SERVICE BULLETIN

N° **139-522**

**ATA 95 - INSTALLATION OF COCKPIT AND CABIN PASSENGER FLOOR BALLISTIC PROTECTIONS**

To provide all necessary instructions on how to perform the installation of the kit cockpit floor ballistic protection P/N 4G9580F00311, kit cockpit door ballistic protection P/N 4G9580F00411 and kit cabin passenger floor ballistic protection P/N 4G9580F00911.

**Figure 2**

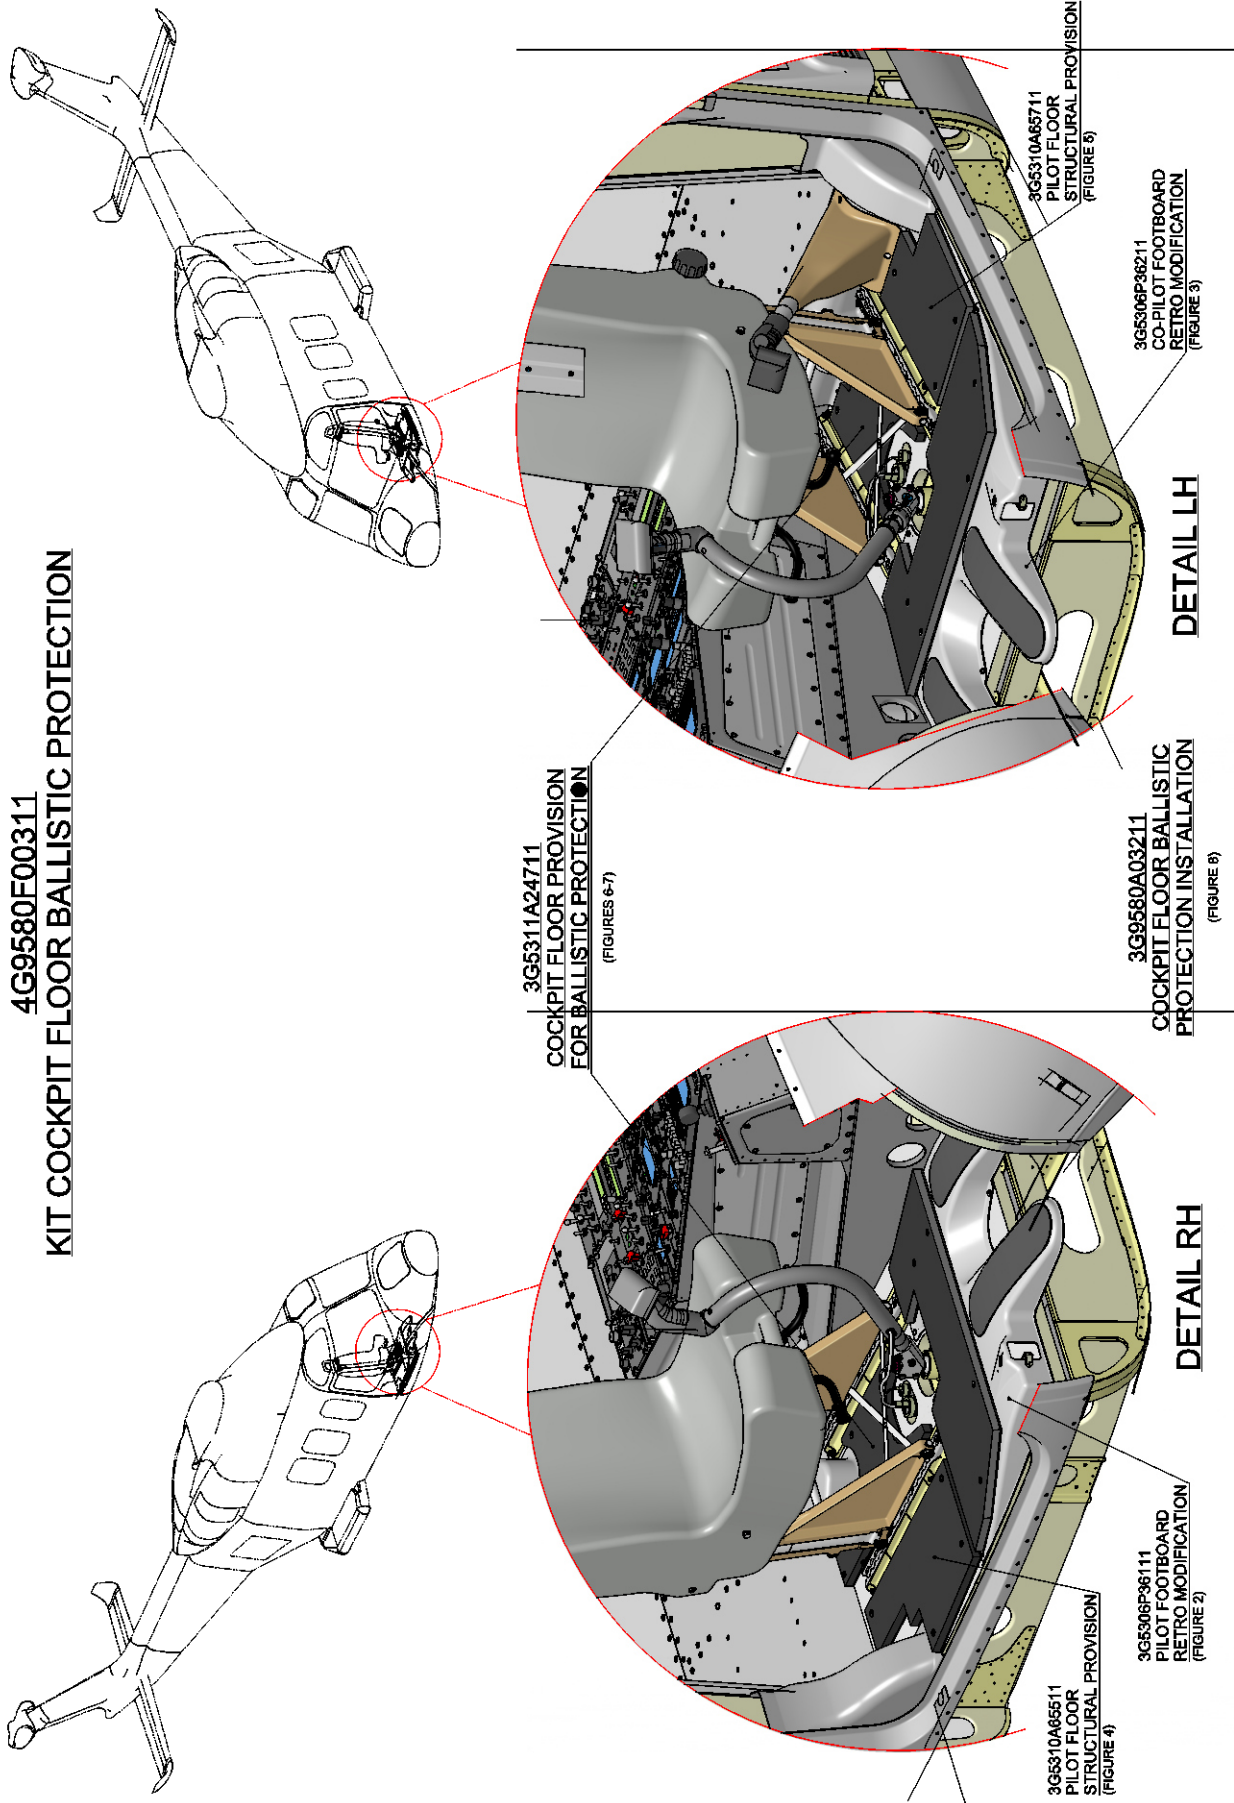
- 2.1.3 With reference to Figure 2 Section B-B, drill n°4 holes Ø19.5 thru upper skin and core in the previously countermarked positions and install n°4 inserts P/N SL10414-4-4A by means of adhesive EA934NA.

Figure 3

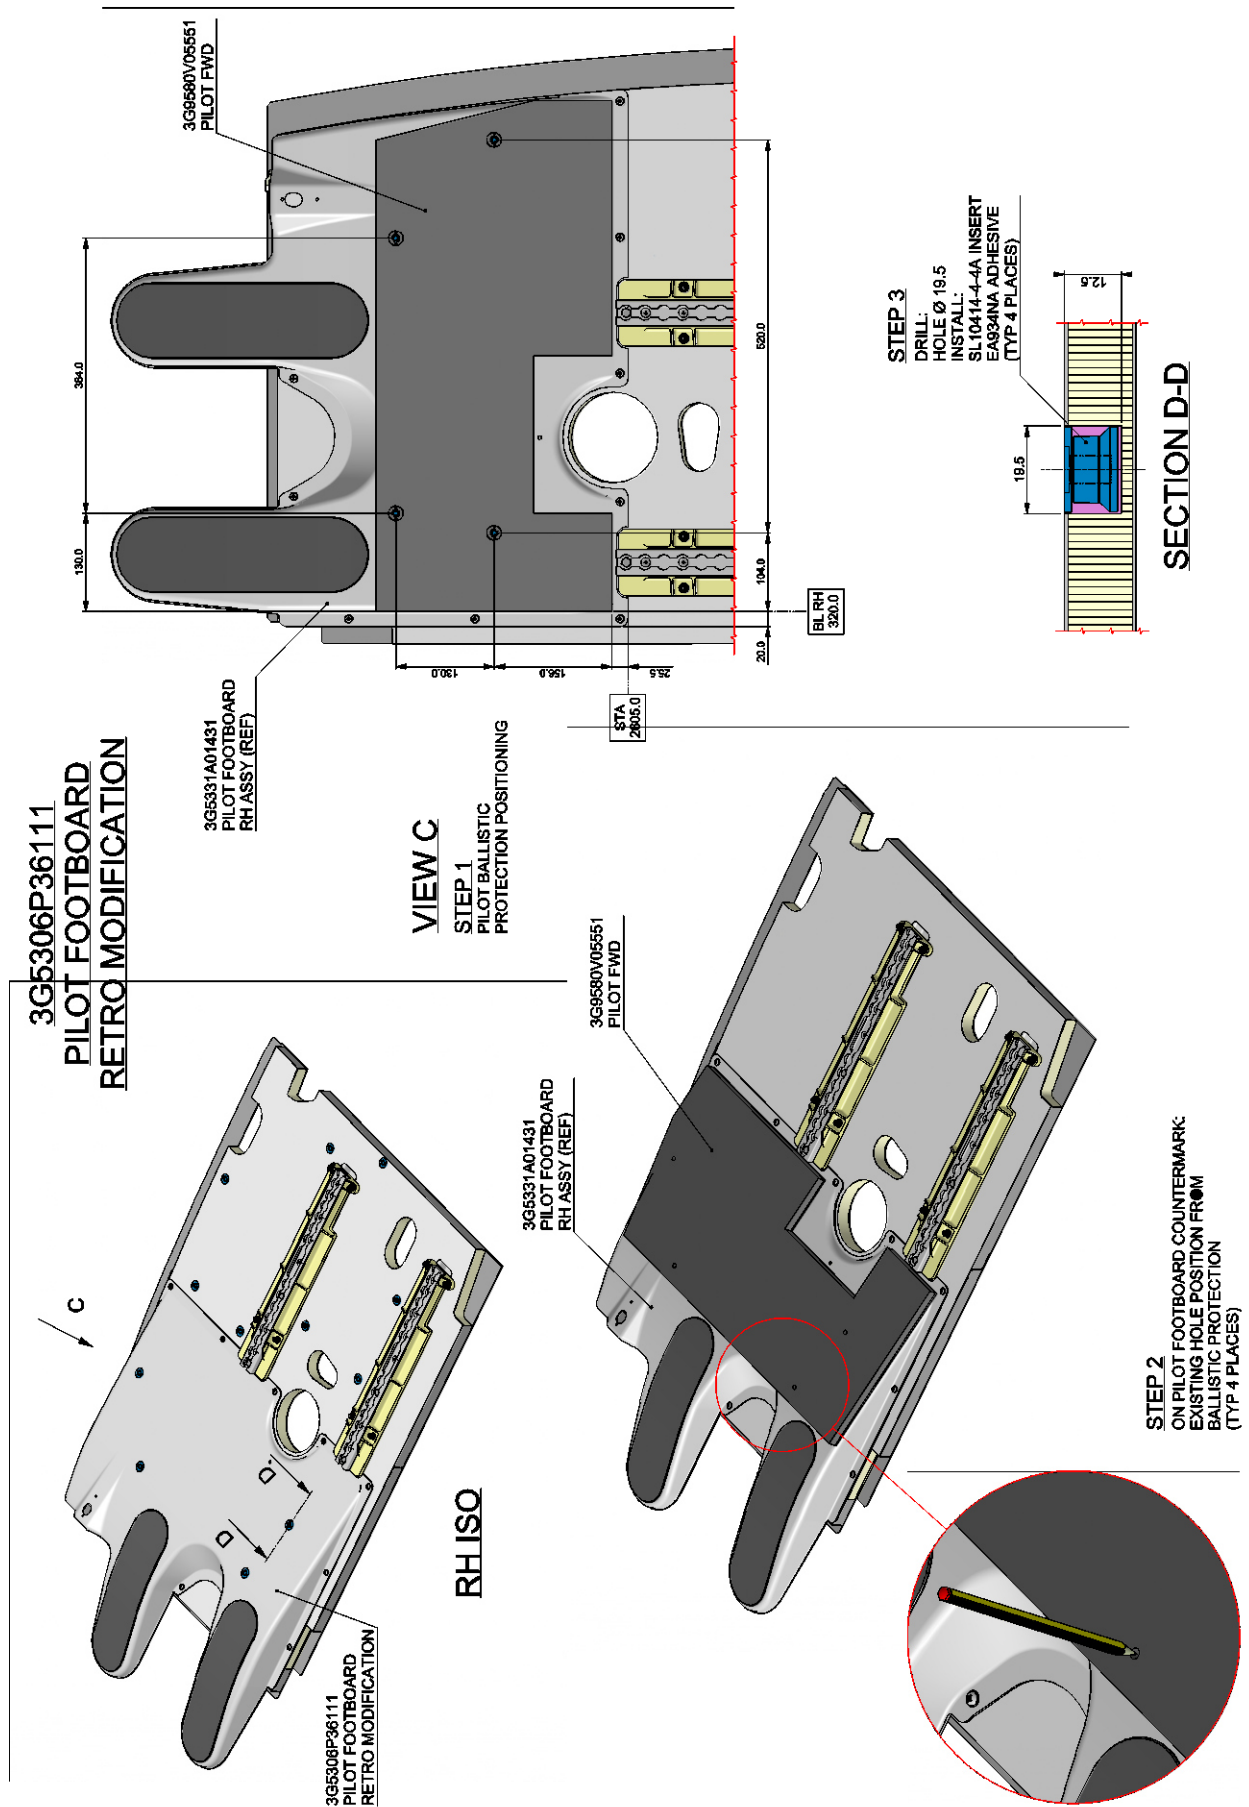
- 2.2.1 With reference to Figure 3 View C, temporarily position the pilot footboard protection P/N 3G9580V05551 on the footboard RH assy P/N 3G5331A01431 in its installation position.

- 2.2.2 Countermark the position of the n°4 holes to drill on the on the footboard RH assy.
  - 2.2.3 With reference to Figure 3 Section D-D, drill n°4 holes Ø19.5 thru upper skin and core in the previously countermarked positions and install n°4 inserts P/N SL10414-4-4A by means of adhesive EA934NA.

**Figure 4**

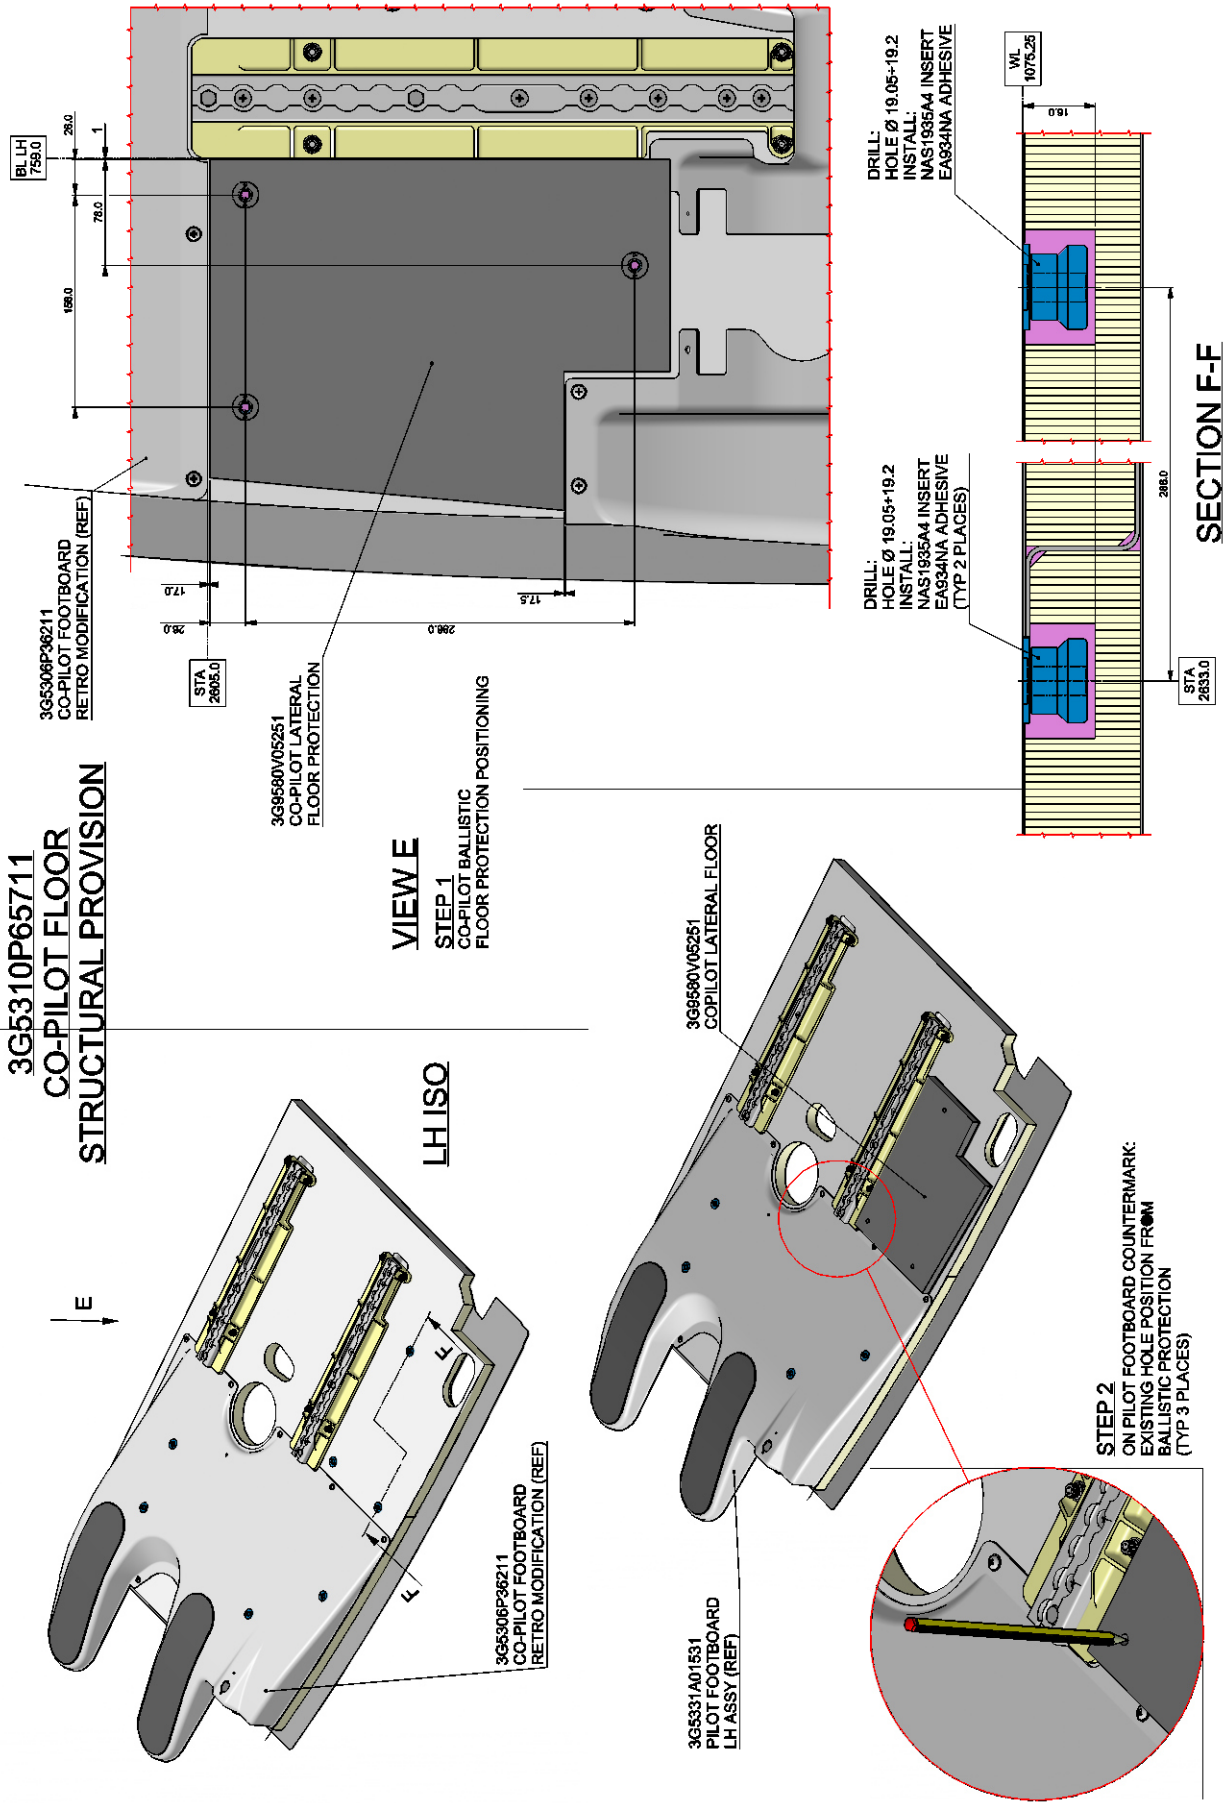
- 2.3.1 With reference to Figure 4 View E, temporarily position the co-pilot lateral floor protection P/N 3G9580V05251 on the co-pilot floor panel in its installation position.

- 2.3.2 Countermark the position of the n°4 holes to drill on the co-pilot floor panel.
  - 2.3.3 With reference to Figure 4 Section F-F, drill n°3 holes Ø19.05÷19.2 thru upper skin and core in the previously countermarked positions and install n°3 inserts P/N NAS1935A4 by means of adhesive EA934NA.

- 2.4.2 Countermark the position of the n°4 holes to drill on the pilot floor panel.
  - 2.4.3 With reference to Figure 4 Section H-H, drill n°4 holes Ø19.05÷19.2 thru upper skin and core in the previously countermarked positions and install n°4 inserts P/N NAS1935A4 by means of adhesive EA934NA.

Figure 5

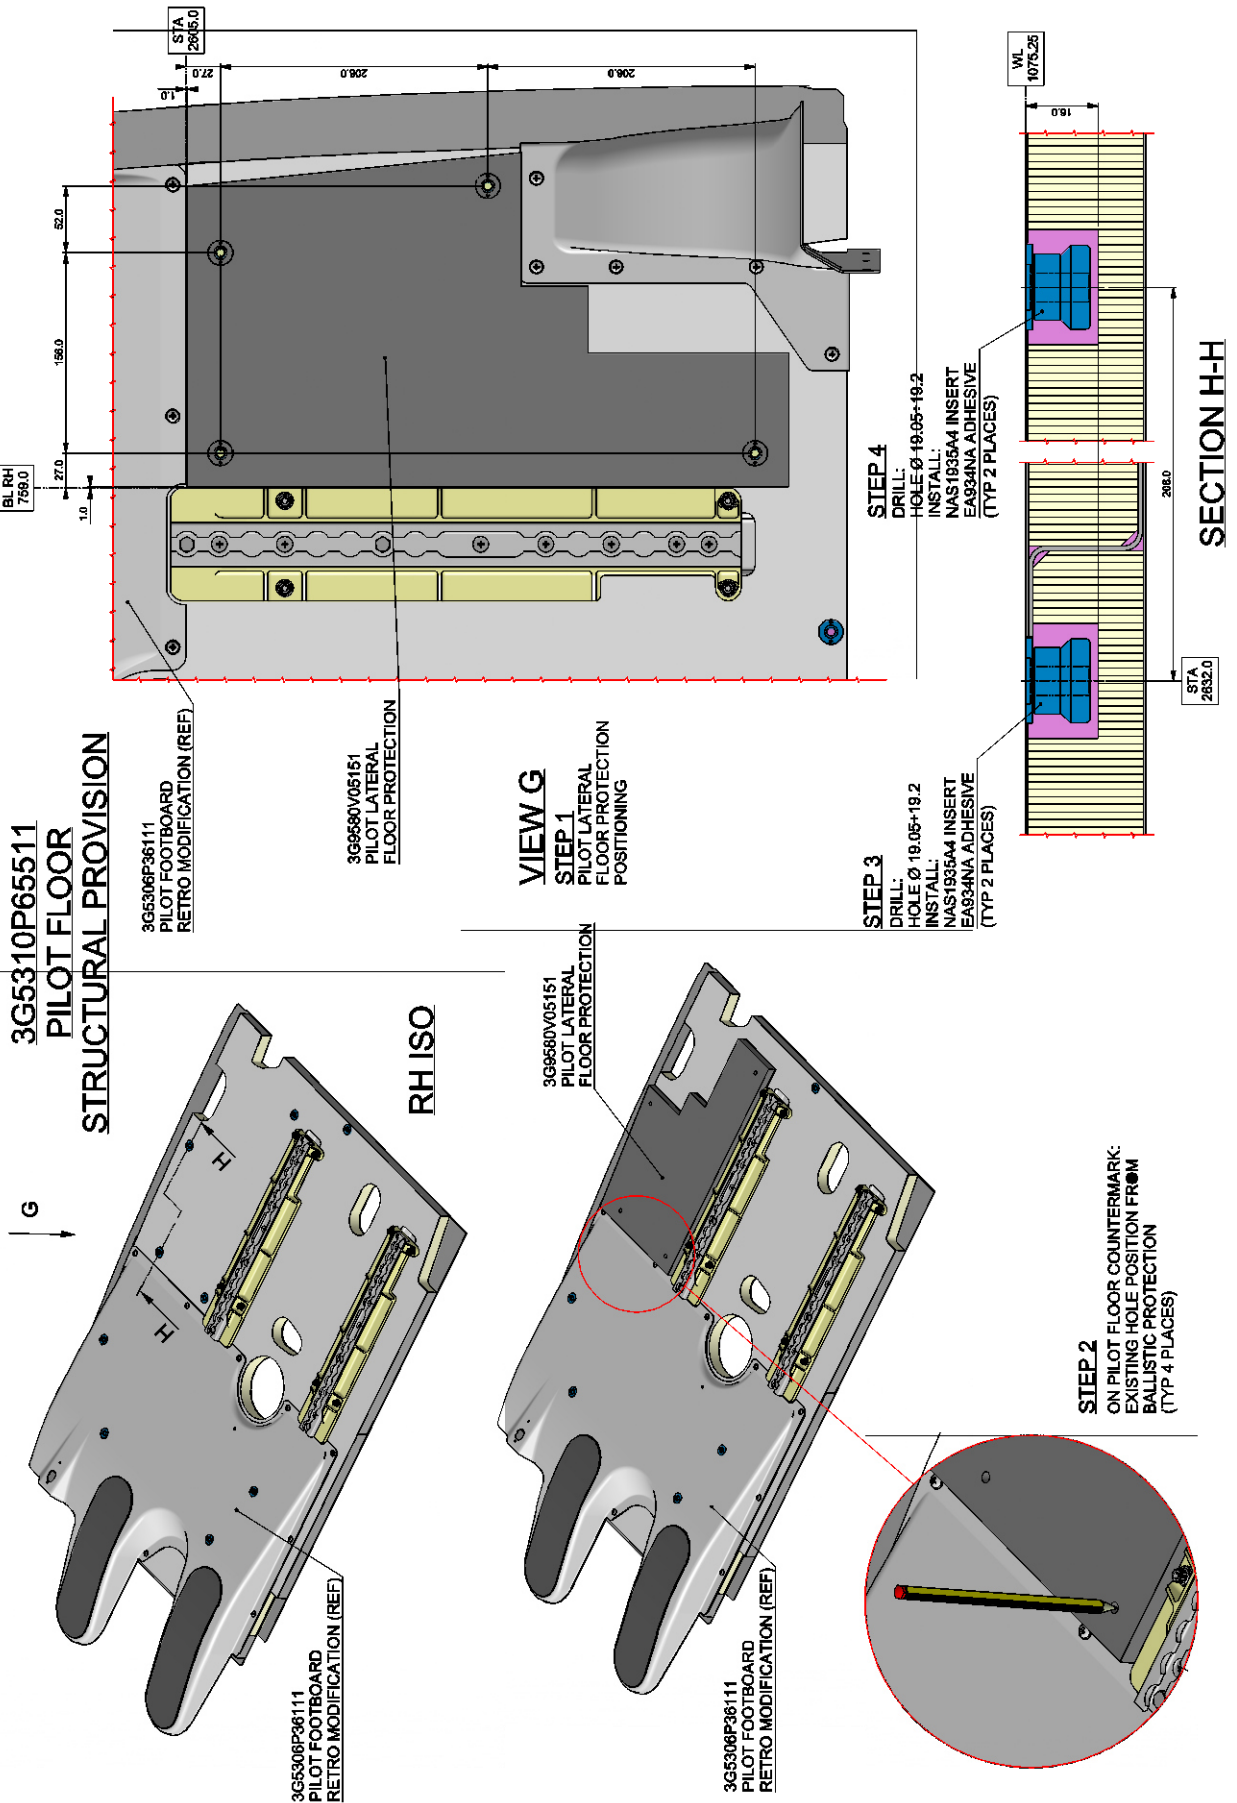
- 2.4 Perform the pilot floor structural provision P/N 3G5310P65511 as described in the following procedure:
  - 2.4.1 With reference to Figure 5 View G, temporarily position the pilot lateral floor protection P/N 3G9580V05151 on the pilot floor panel in its installation position.
